ATTACHMENT I to JPN-94-050

REVISED TECHNICAL SPECIFICATION PAGES FOR
PROPOSED TECHNICAL SPECIFICATION CHANGES

INSTRUMENTATION SURVEILLANCE TEST INTERVALS,
ALLOWABLE OUT-OF-SERVICE TIMES, AND OTHER CHANGES

JAMES A. FITZPATRICK NUCLEAR POWER PLANT

FIG. 4 I-1
GRAPHICAL AID IN THE SELECTION OF AN ADEQUATE INTERVAL BETWEEN TESTS

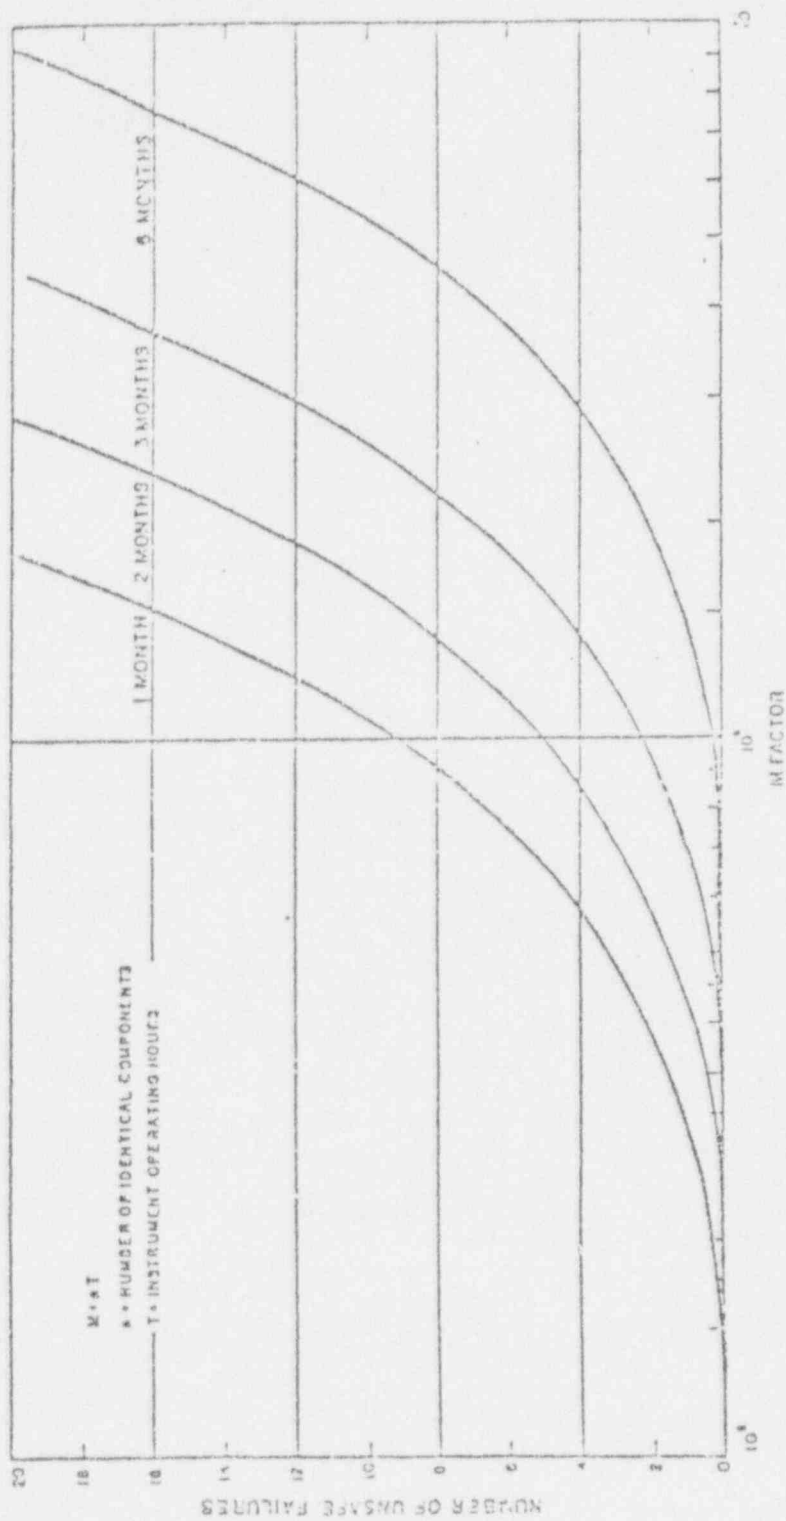
J. Figure 4.1-1, Page 48

Delete Figure 4.1-1 since it is referenced in text deleted by change F.6. (CAT 1)

Delete Figure

FIG. 4.2-1
TEST INTERVAL VS PROBABILITY OF SYSTEM UNAVAILABILITY

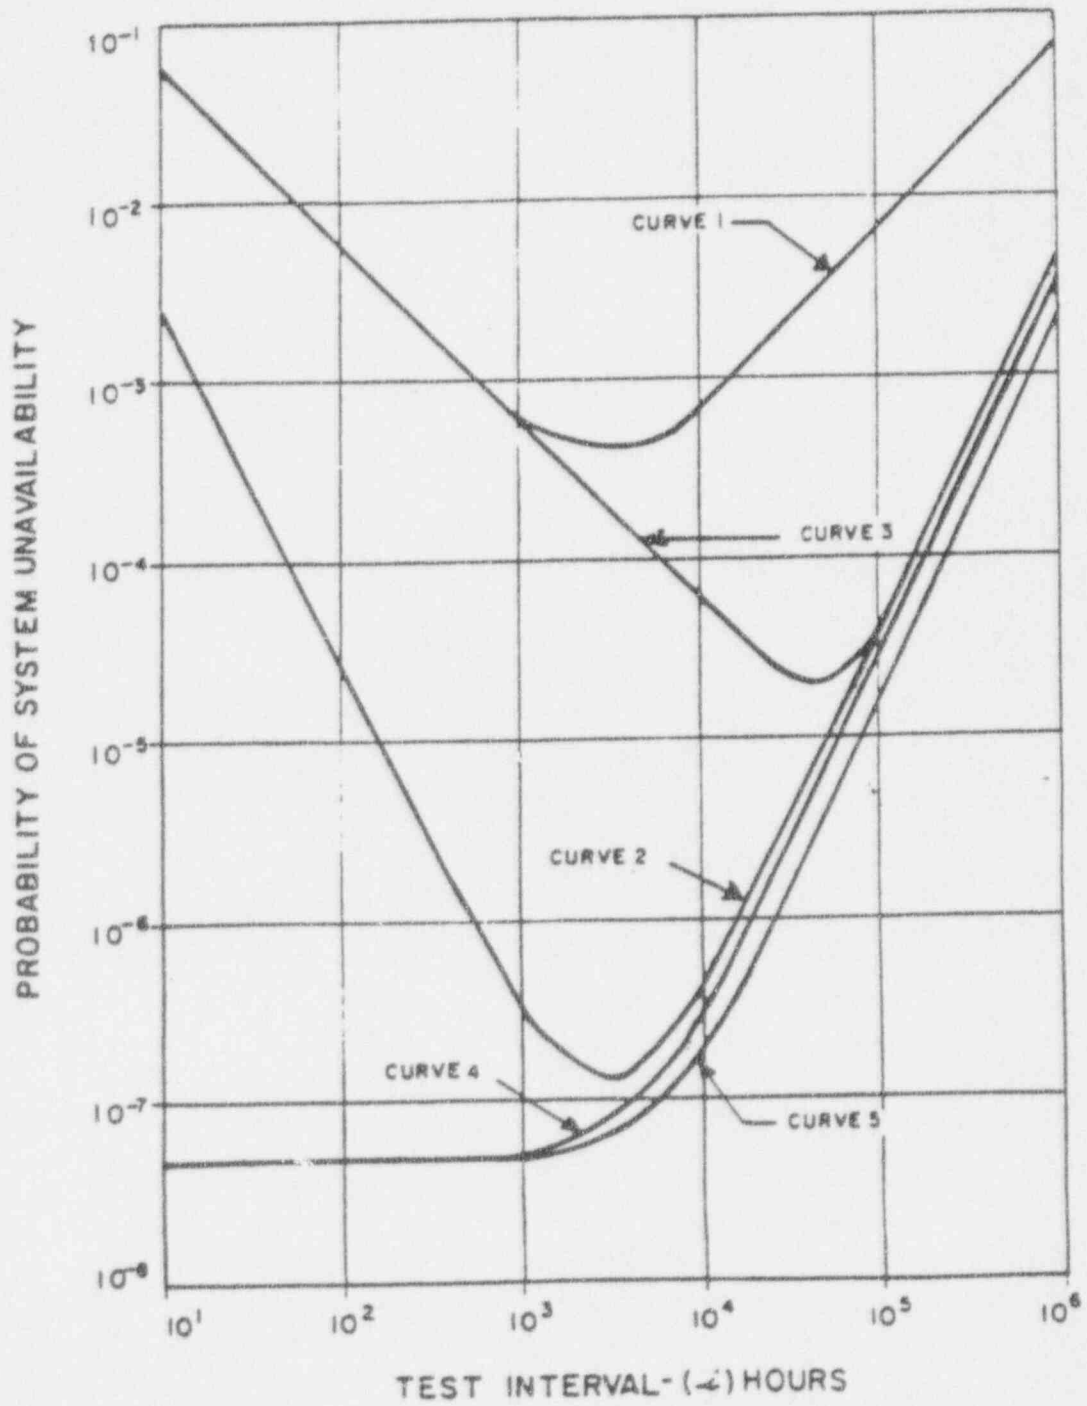
2. Revise the title of the table. (CAT 4)
- Y. Figure 4.2-1, Test Intervals vs. Probability of System Unavailability, Page 87
- Page 87: Delete Figure 4.2-1 since it is referenced in text deleted by change N.1. (CAT 1)

Delete Fig. 4.2-1
